**Project**  
60 Whitfield Street

Existing Elevation - South East face

Drawing No	Revisions
60WS-A-SBA-DR-XX-4009-C3

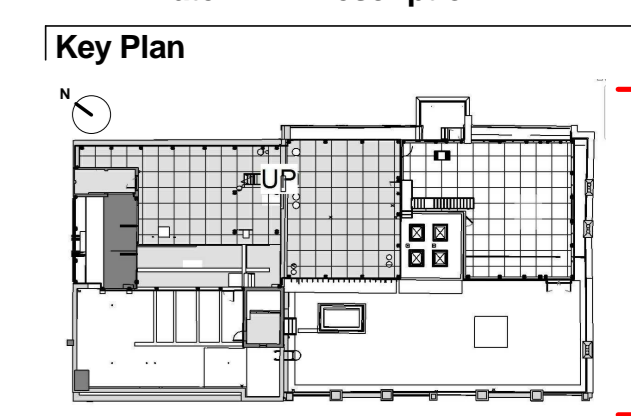
- Notes**
-  Indicates elements to be demolished as approved scheme
  -  Variations proposed under this application
- Minor Changes Key**
-  Planning Approval Building Boundary
  -  Planning Approval Plant Boundary
- ① Louvre added to enclose MEP
  - ② Existing enclosure of Goldbeaters atrium is retained except two lateral walls
  - ③ Scope of demolition of existing plant room on Walport building increased
  - ④ Minor repositioning of approved flues
  - ⑤ Maintenance cat ladder added to link Goldbeaters terrace with Walport terrace
  - ⑥ Amended stair-landing levels
  - ⑦ Parapet of dumbwaiters enclosure raised by 235mm
  - ⑧ Reduced louvre height to match Howland Mews elevation
  - ⑨ One section of window removed
